Groundwater Transfer Review Summary Form

Transfer/PA # T- 14810

Application: T-14810

1. Basic description of the changes proposed in this transfer: Permit Amendment for G-15267 to change location for proposed Well #3 location approximately 2,000 ft NW of original proposed location.

Figure 2: Hydrograph showing POA 1 and 2 and their respective trigger levels for their permit decline conditions.

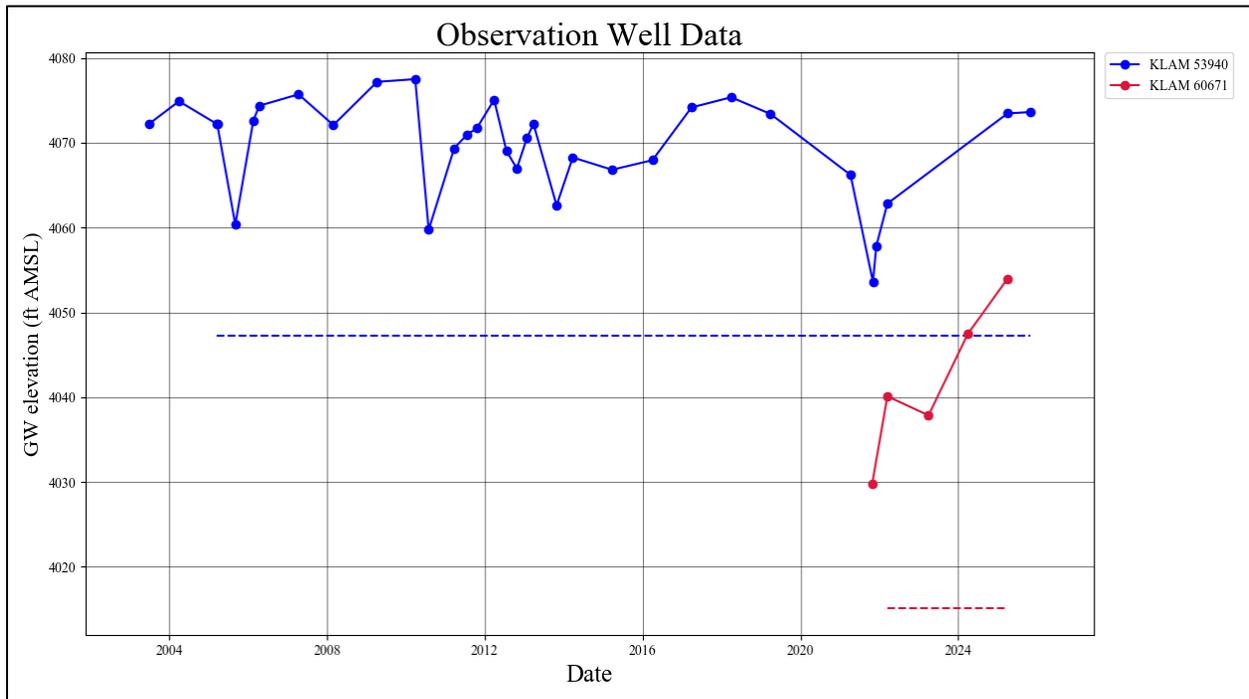
Hydrograph with trigger levels is included as Figure 2. Decline conditions have not yet been exceeded for POA 1 & 2. Another hydrograph with additional nearby wells is included as Figure 3.

Figure 3: Hydrograph showing nearby wells KLAM 52916 and KLAM 53771 plotted along with POA 1 and 2.

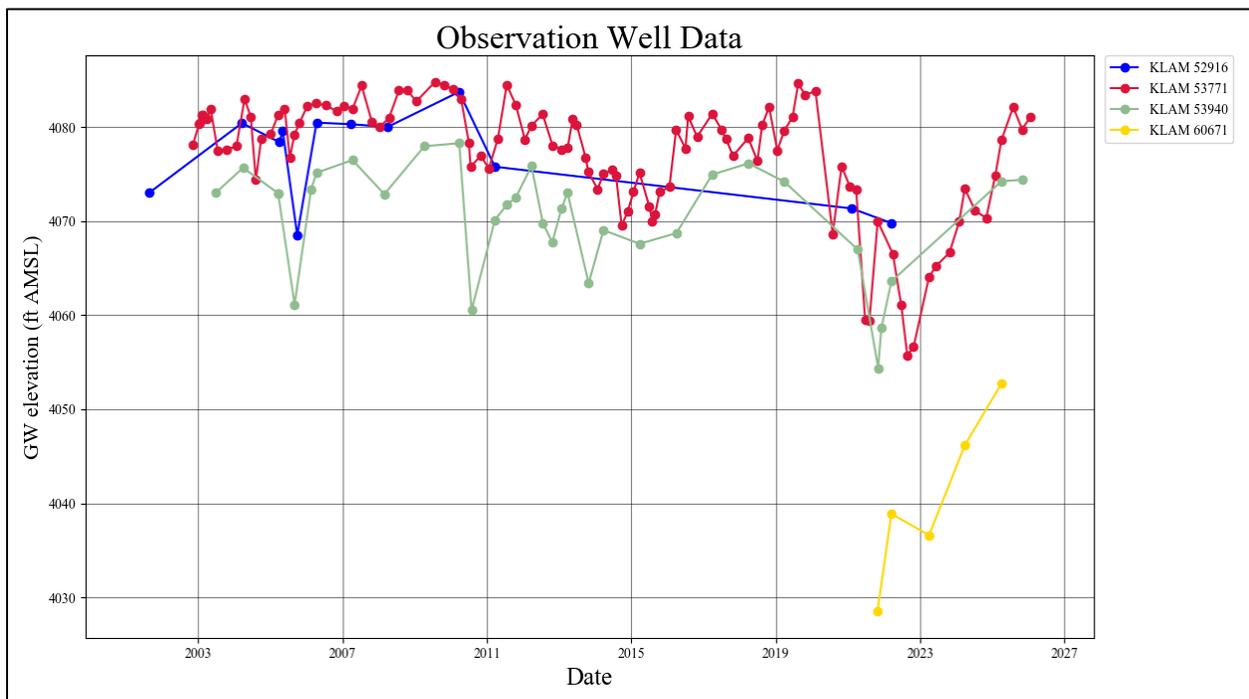
- Yes No Comments: _____
8. What conditions or other changes in the application are necessary to address any potential issues identified above: _____
9. Any additional comments: The second hydrograph (Figure 3) shows POA 1 (KLAM 53940) tracks very well with the KLAM 52916 and KLAM 53771. However, the Spring 2025 water level for nearby POA 2 (KLAM 60671) is approximately 22 ft lower than POA 1 while still following the general trend exhibited by the other wells. This may be due to widespread faults in the area creating preferential pathways between some faults more than others. Due to the proximity of the proposed location to KLAM 53771, it is likely that the water levels will be similar to the shallower water levels shown by the selected hydrograph wells and POA 1. Once the construction of POA 3 is complete and a ground water level trend is established for that location, a reference level will need to be set for the well that is representative of the groundwater level in March of 2004, the year after first use occurred under the permit.

Figure 4: Estimated drawdown for pumping from proposed POA 3

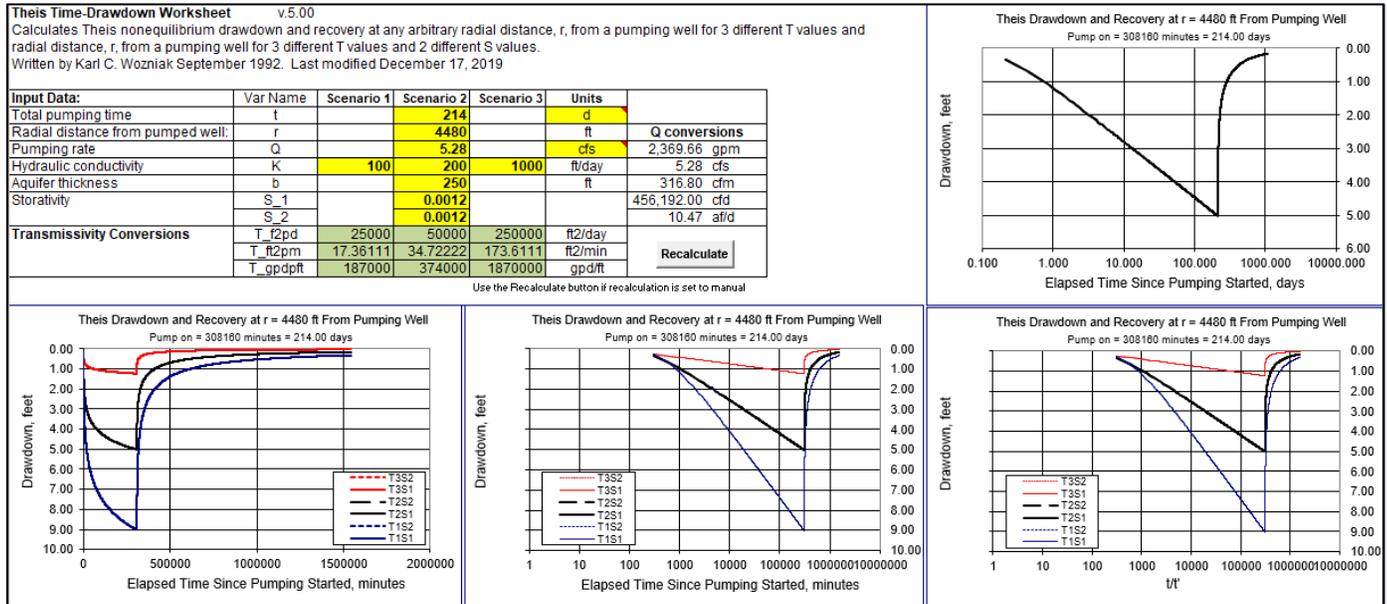
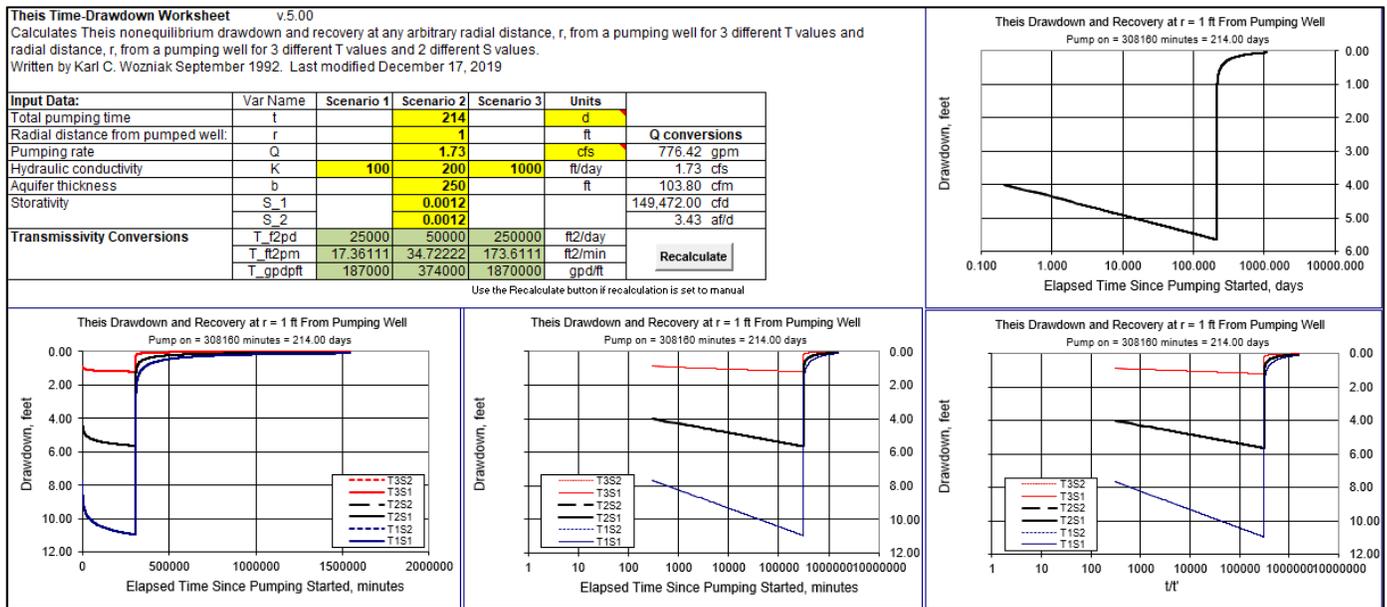
A Theis drawdown analysis was performed using aquifer parameters given in (Gannett et al., 2007) and pump tests in T40S-R09E in our Pump Test database. A screenshot of the analysis and parameters used is included below as Figures 4 & 5. Using the most conservative estimate and pumping at max rate for 214 days, the estimated increase in drawdown from the proposed change would be an additional 0.93 ft resulting in a maximum drawdown of 19.98 ft. The estimate considers pumping from both the proposed POA as well as the affected well (KLAM 52916). The results of this estimate suggest that injury is unlikely to occur as a result of the proposed change.
